Your Ref
M/49/15/HH
Our Ref
PLAN-009764
Date
21/05/2015

Proposal: Conversion of existing integral garage into habitable space to include single storey extension.

Site: 24 Southdean Drive, Middleton-on-Sea, PO22 7SX.
M/49/15/HH

Southern Water MapGuide Browser

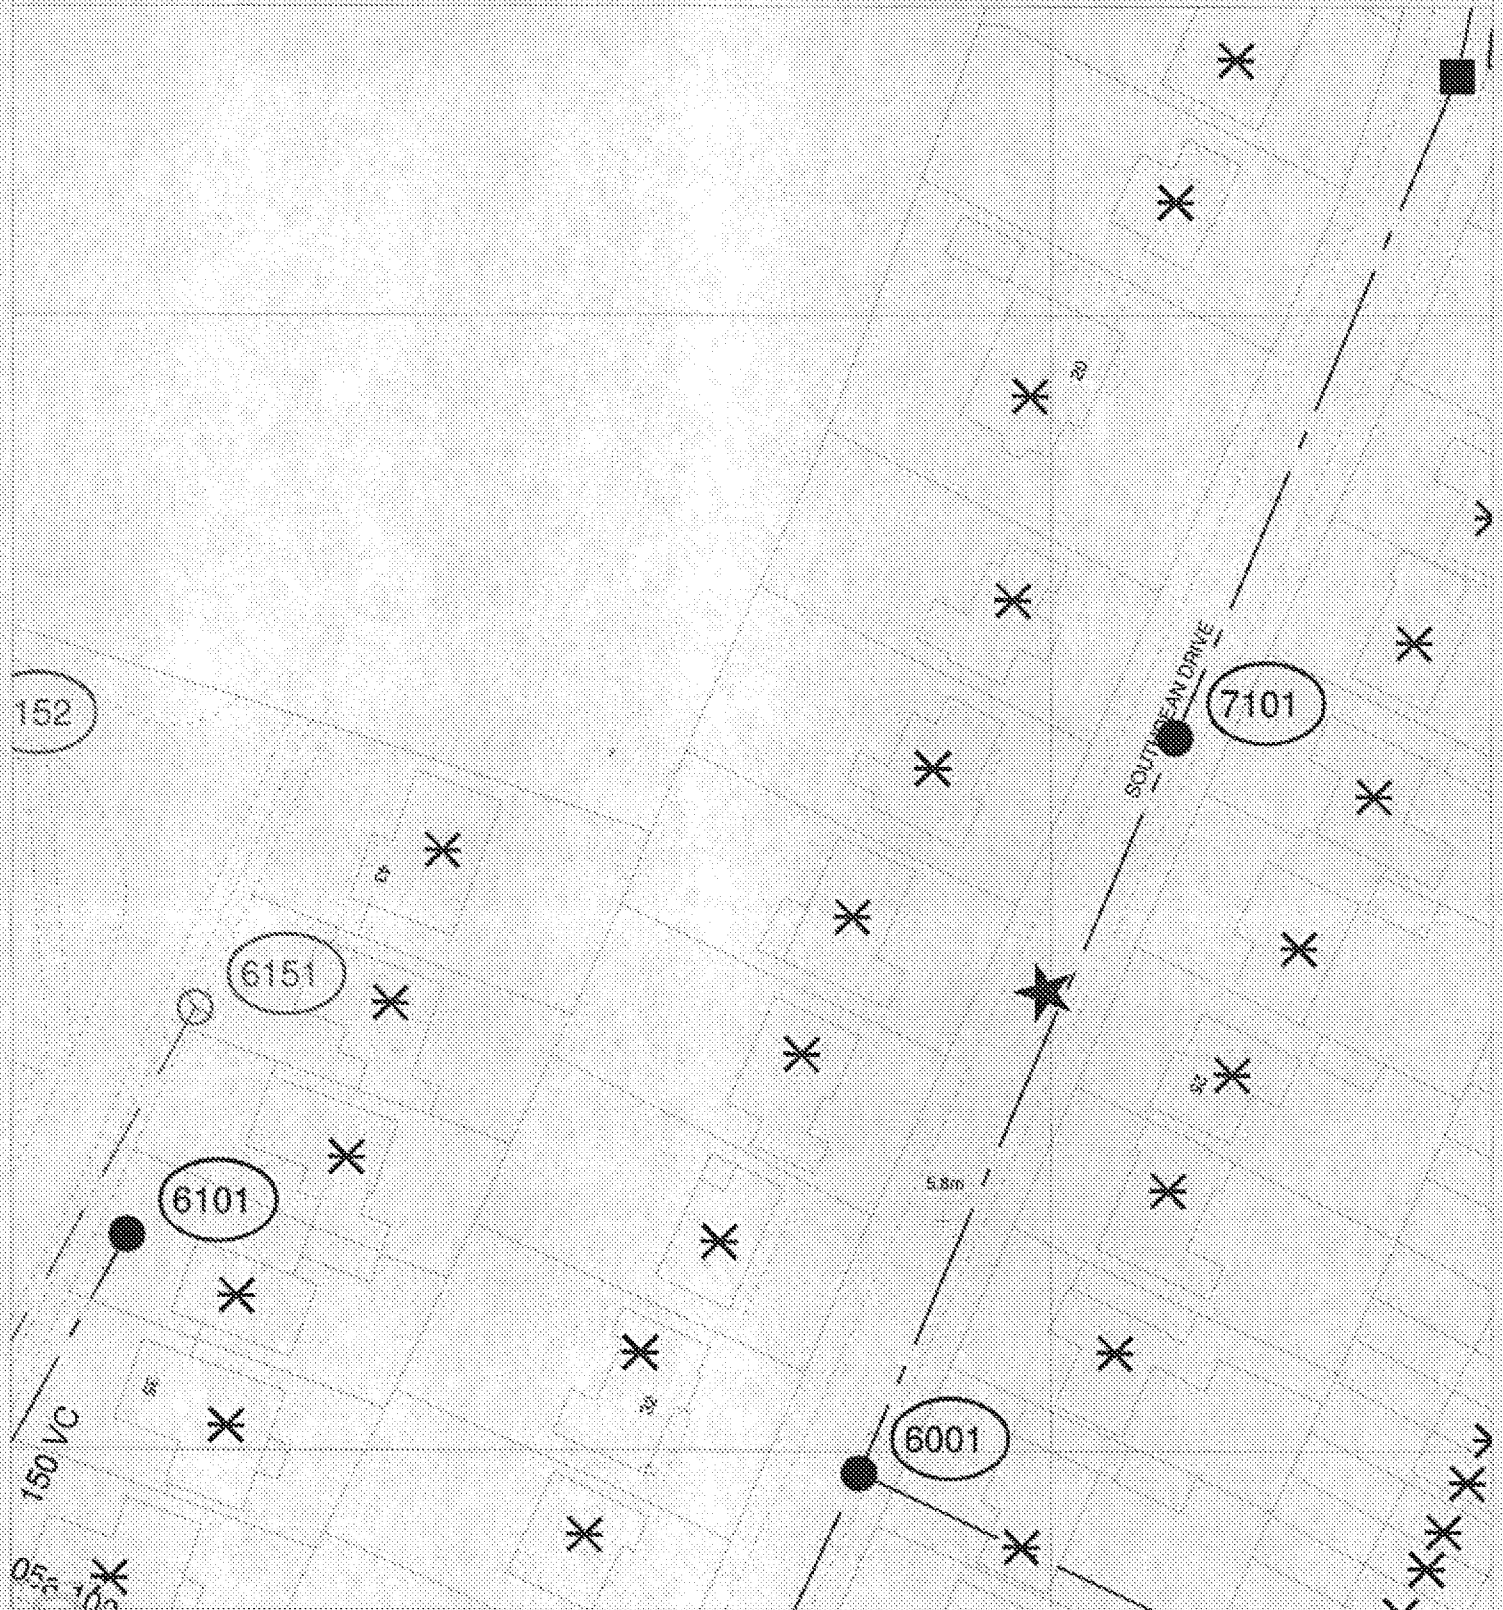
Due to changes in legislation that came in to force on 1st October 2011 regarding the future ownership of sewers it is possible that a sewer now deemed to be public could be crossing the above property. Therefore, should any sewer be found during construction works, an investigation of the sewer will be required to ascertain its condition, the number of properties served, and potential means of access before any further works commence on site.

The positions of pipes shown on this plan are believed to be correct, but Southern Water Services Ltd accept no responsibility in the event of inaccuracy. The actual positions should be determined on site.

The applicant is advised to discuss the matter further with Southern Water, Sparrowgrove House Sparrowgrove, Otterbourne, Hampshire SO21 2SW (Tel: 0330 303 0119) or www.southernwater.co.uk".
